SAS SUPERSTRUCTURE - CONDUIT AND CABLE TRAY PLAN

CONTRACT CHANGE ORDER NO. _____
 SHEET _____ OF _____

SAS SUPERSTRUCTURE GIRDER WESTBOUND LIGHTING AND ELECTRICAL SYSTEMS

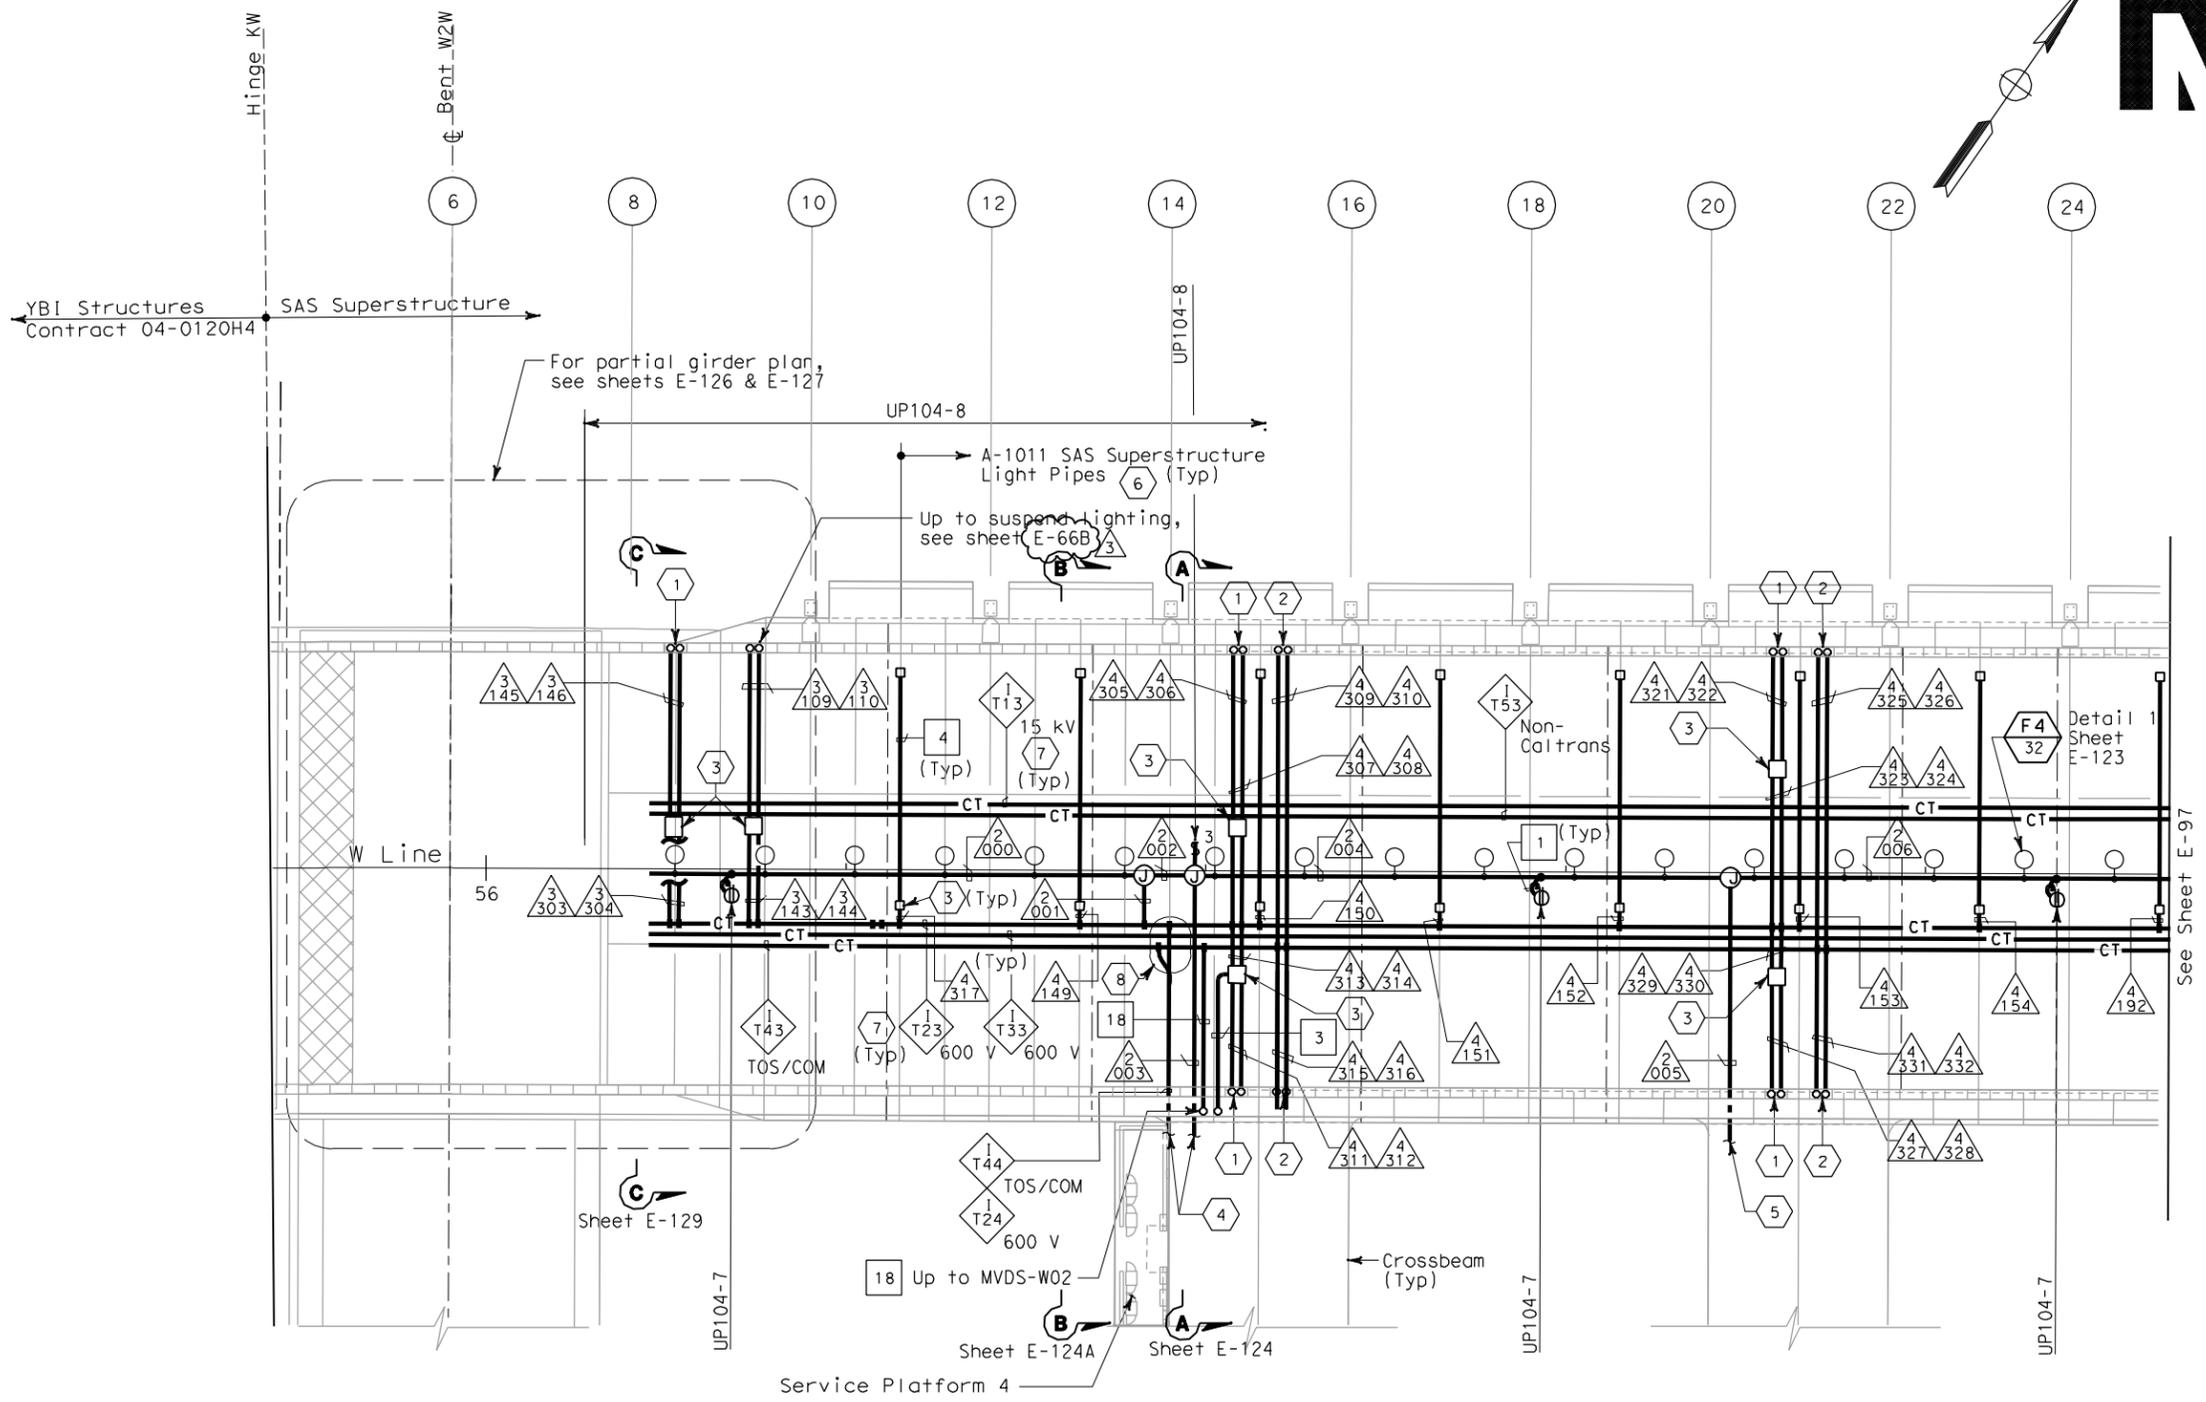
MARK	DATE	DESCRIPTIONS	BY	CH'D	CCO#
3	06/25/09	WEST END BARRIER CONDUIT	RG	FW	44S1
2	02/25/08	CABLE TRAY CHANGES	RG	FW	42S1
1	02/19/08	ELECTRICAL MODIFICATIONS	MP	RR	42
